# HISTORIC AND DESIGN REVIEW COMMISSION

March 17, 2021

**HDRC CASE NO:** 2021-098  
**ADDRESS:** 911 N PINE ST  
913 N PINE ST  
915 N PINE ST  
917 N PINE ST  
**LEGAL DESCRIPTION:** NCB 531 (PINE AT HAYS {IDZ}), BLOCK 13 LOT 25  
NCB 531 (PINE AT HAYS {IDZ}), BLOCK 13 LOT 26  
NCB 531 (PINE AT HAYS {IDZ}), BLOCK 13 LOT 27  
NCB 531 (PINE AT HAYS {IDZ}), BLOCK 13 LOT 28  
**ZONING:** IDZ, H  
**CITY COUNCIL DIST.:** 2  
**DISTRICT:** Dignowity Hill Historic District  
**APPLICANT:** Khi Ransome  
**OWNER:** Charles Turner/K/T TX HOLDINGS & T/A APARTMENTS INC  
**TYPE OF WORK:** Carport installation  
**APPLICATION RECEIVED:** February 04, 2021  
**60-DAY REVIEW:** Not applicable due to City Council Emergency Orders  
**CASE MANAGER:** Edward Hall  
**REQUEST:**

The applicant is requesting a Certificate of Appropriateness for approval to install carports to accompany the previously approved mixed-use structures at 911 through 917 N Pine, located within the Dignowity Hill Historic District.

**SITE PLAN  
CARPORTS**

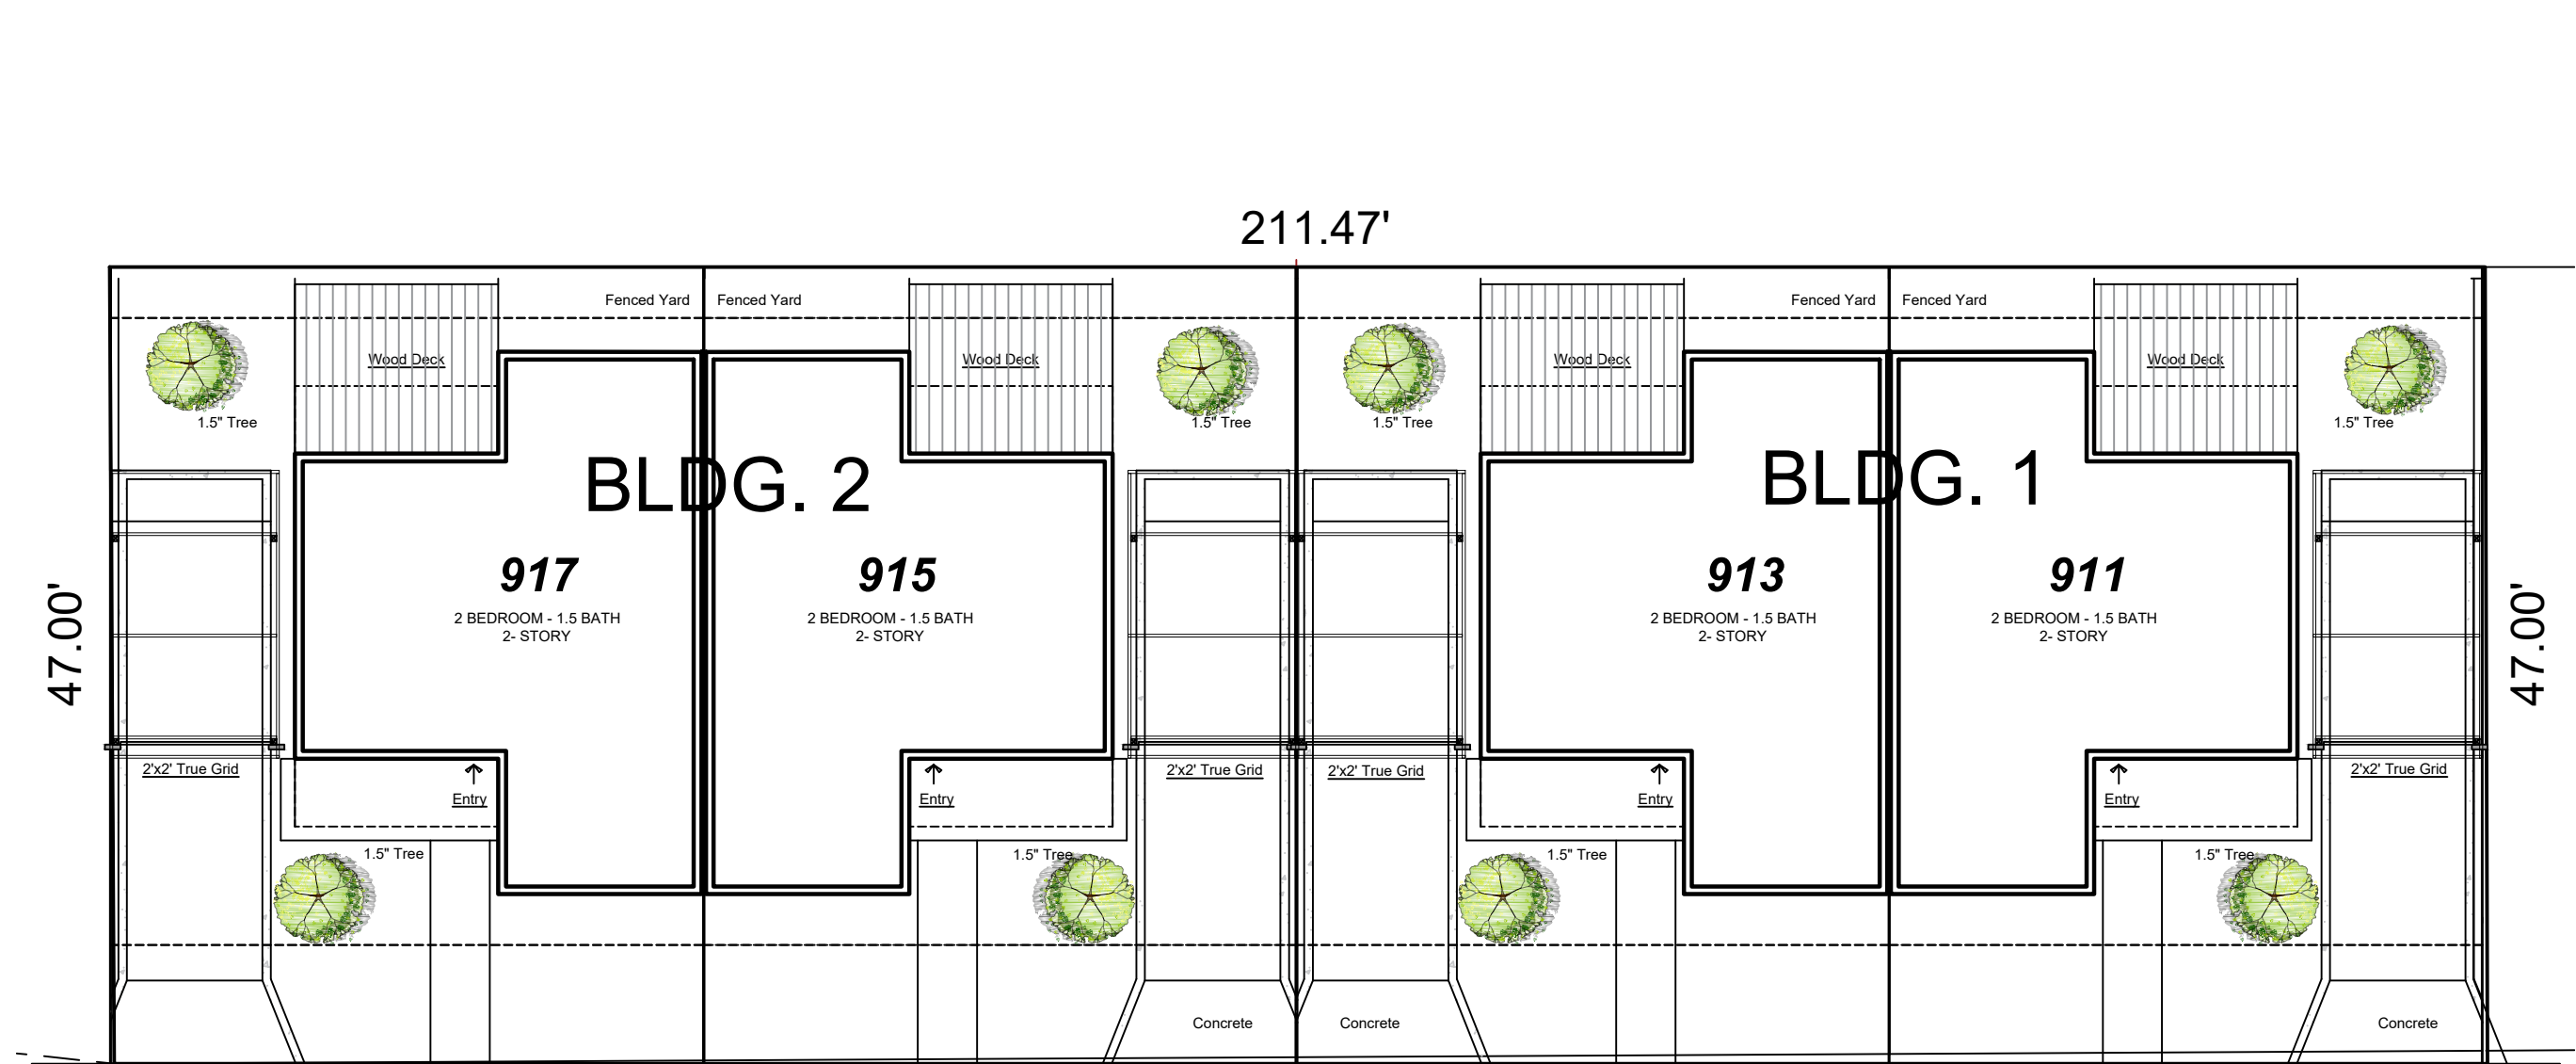
- d. **SETBACKS & ORIENTATION** – The Guidelines for New Construction 5.B. note that the predominant garage orientation found along the block should be matches. Additionally, the Guidelines note that setbacks of new accessory structures should be similar to the setbacks of those found historically in the district. Staff finds the proposed carport structures to be sited consistently with the Guidelines.

**SIDE ELEVATION**

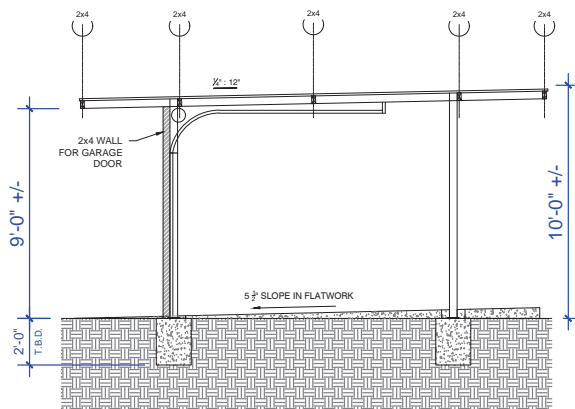
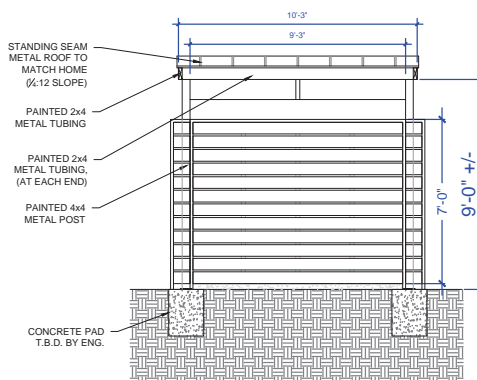
- b. **ACCESSORY STRUCTURE (Massing)**– The Guidelines for New Construction 5.A. note that new accessory structures should be designed to be visually subordinate to the primary historic structure on the lot in terms of their height, massing and form; and should be no larger than forty (40) percent of the primary historic structure’s footprint. The applicant has proposed both a footprint and an overall height that is subordinate to that of the primary structure and is consistent with the Guidelines.

- c. **ACCESSORY STRUCTURE (Architectural details, materials)** – The Guidelines for New Construction 5.A. note that accessory structures should relate to the period of construction of the primary historic structure on the lot through the use of complementary materials and simplified architectural details. The applicant has proposed for the structure to feature metal tubing, a standing seam metal roof and a rear wall constructed of 2x4 members. The applicant has proposed for the structure to feature a shed roof. Generally, staff finds the proposed design and materials to be appropriate. The proposed standing seam metal roof should feature panels that are 18 to 21 inches wide, seams that are 1 to 2 inches in height and a standard galvalume finish. A crimped ridge seam is to be used and if a ridge cap is requested, it must feature a low profile and be approved by staff prior to installation.

Staff recommends approval based on findings a through d with the following stipulation:

- i. That proposed standing seam metal roof should feature panels that are 18 to 21 inches wide, seams that are 1 to 2 inches in height and a standard galvalume finish. A crimped ridge seam is to be used and if a ridge cap is requested, it must feature a low profile and be approved by staff prior to installation.
